NEBRASKA ARMY NATIONAL GUARD
CATS Warrior Fitness Obstacle Course

220 County Road A, Ashland, NE 68003

PROJECT NO. 31090701

A D D E N D U M N O . 1

CS103

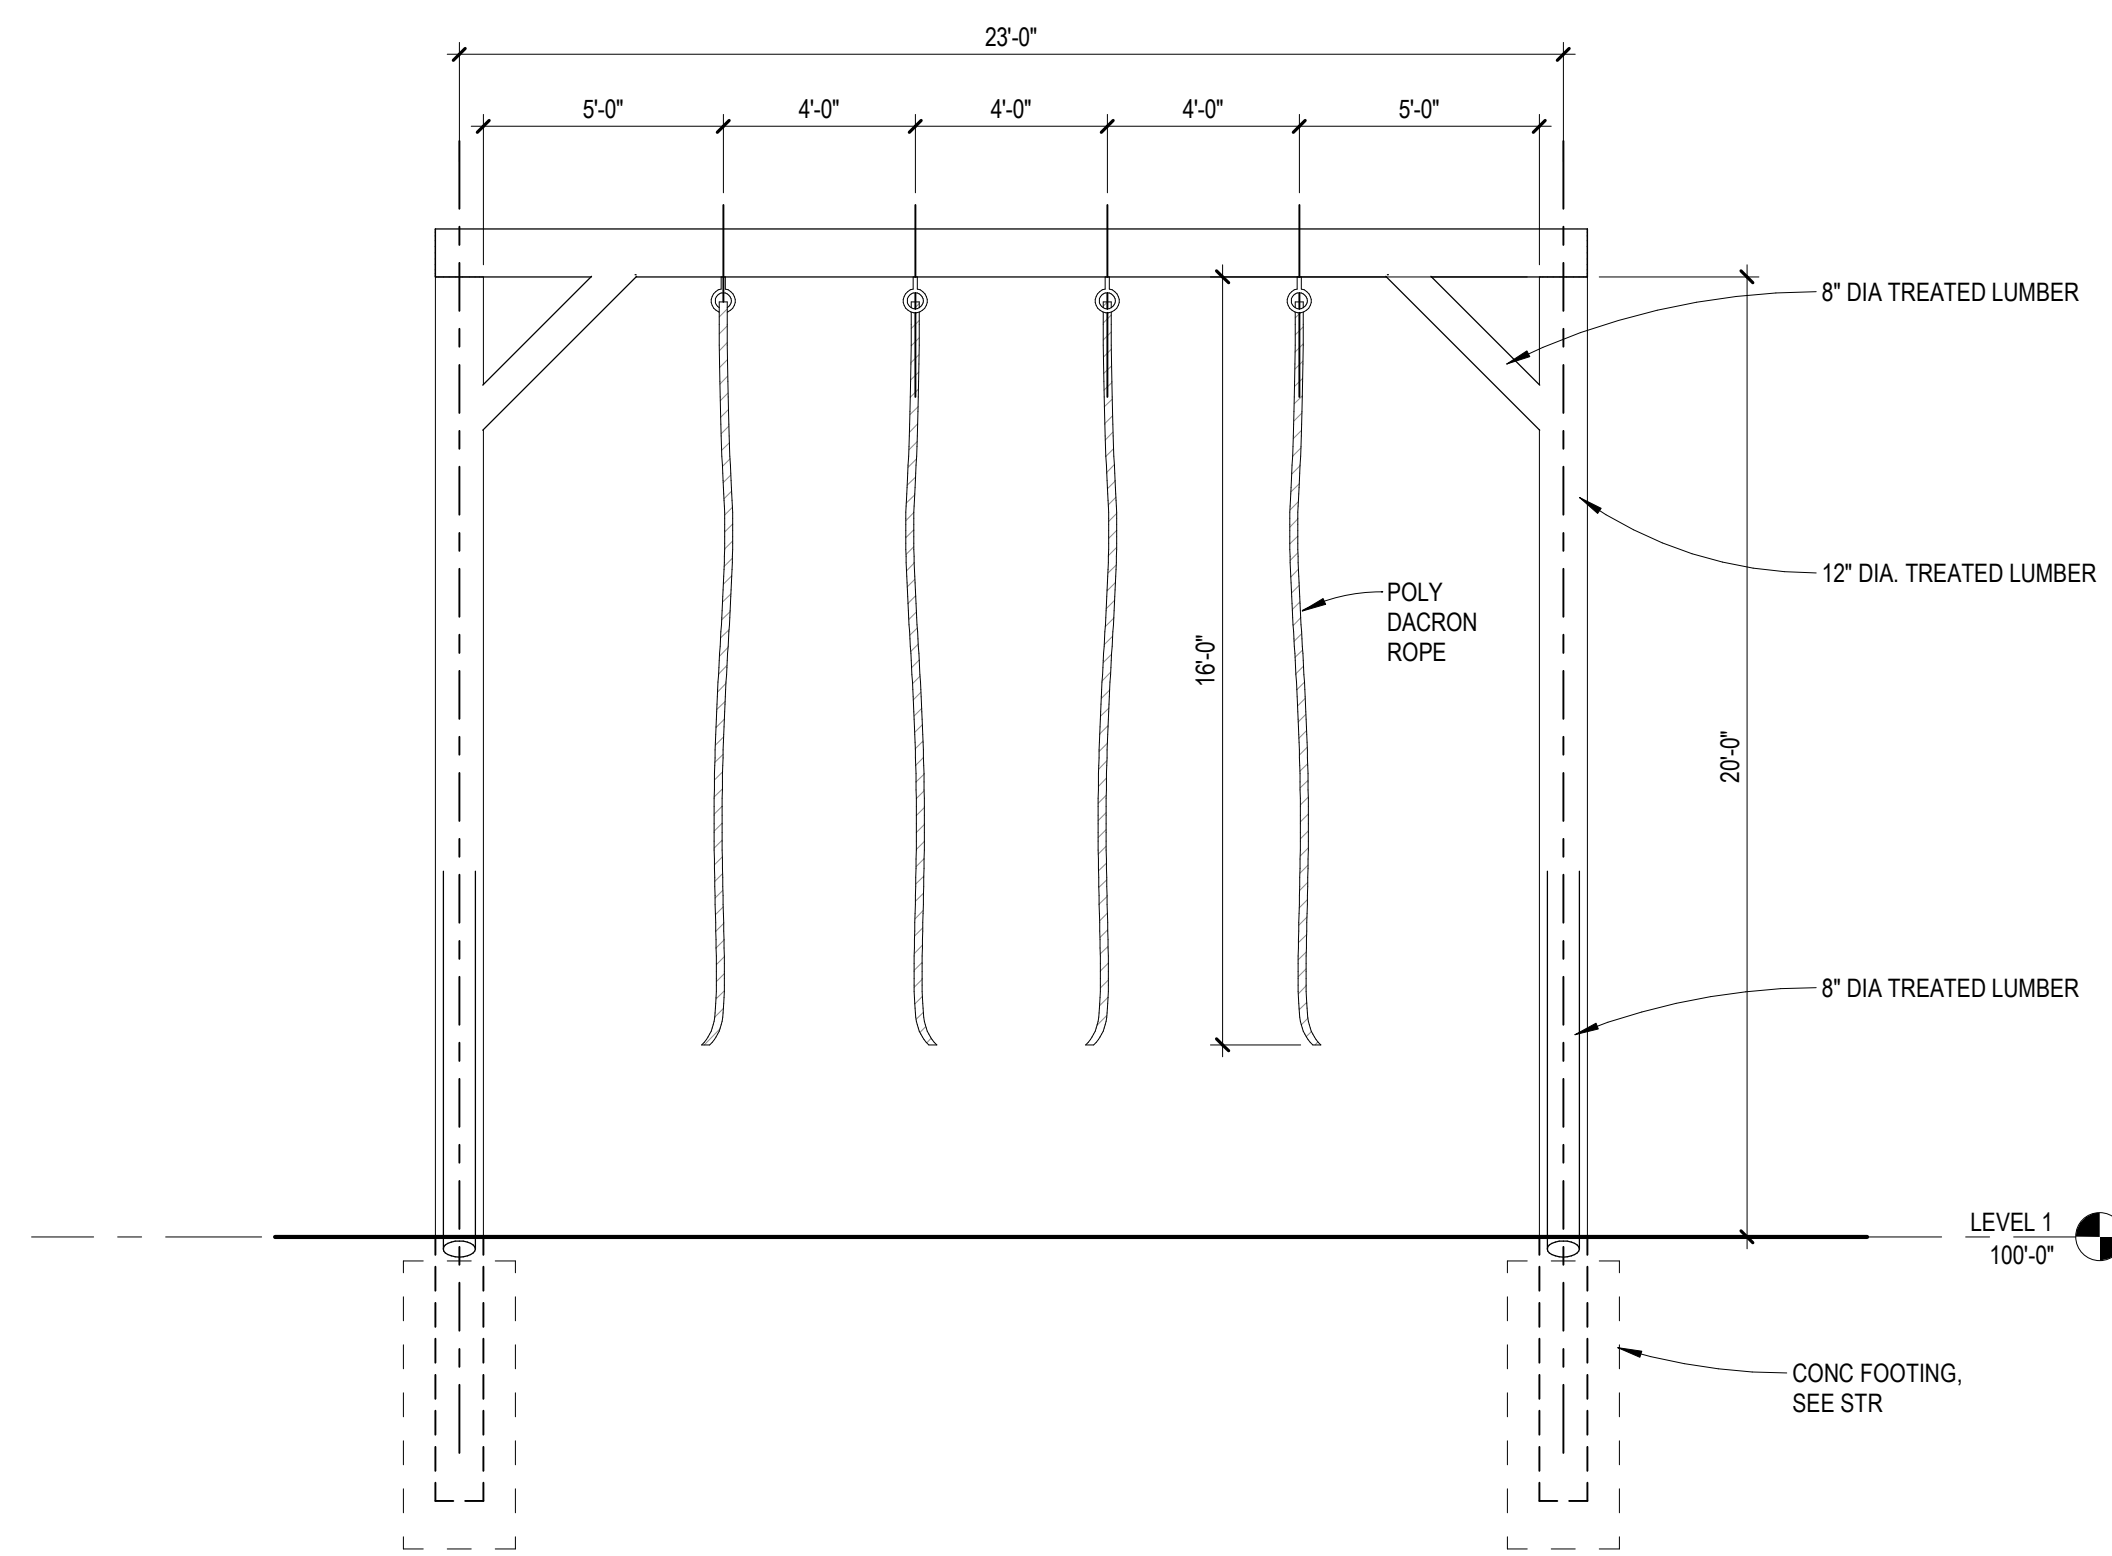
- ADD 1-3 Modification:
Sheet C000 Survey and Staking Notes. Modified Note 8 to clarify Geotechnical Reports are available for adjacent projects from the owner upon request.
- ADD 1-4 Clarification:
Sheet CS102 Added Station location for obstacles W1 and W17.
- ADD 1-5 Clarification:
Sheet CS102 Added note to sheet to clarify belly crawl obstacle is existing.
- ADD 1-6 Clarification:
Sheet CS103 Station marker for Obstacle W4 reoriented to station centerline.
- ADD 1-7 Modification:
Sheet C501 Detail 7 for Angled Monkey Bars Pit Section noted to stagger railroad ties and for rebar pinning adding a second section of rebar and shortened the original section shown.
- ADD 1-8 Modification:
Sheet C507 Detail 4 for Trench Culvert (Pit) Modified note for end of culvert set elevation from 0.25' to 0.17' below beginning grade elevation for pump out point.
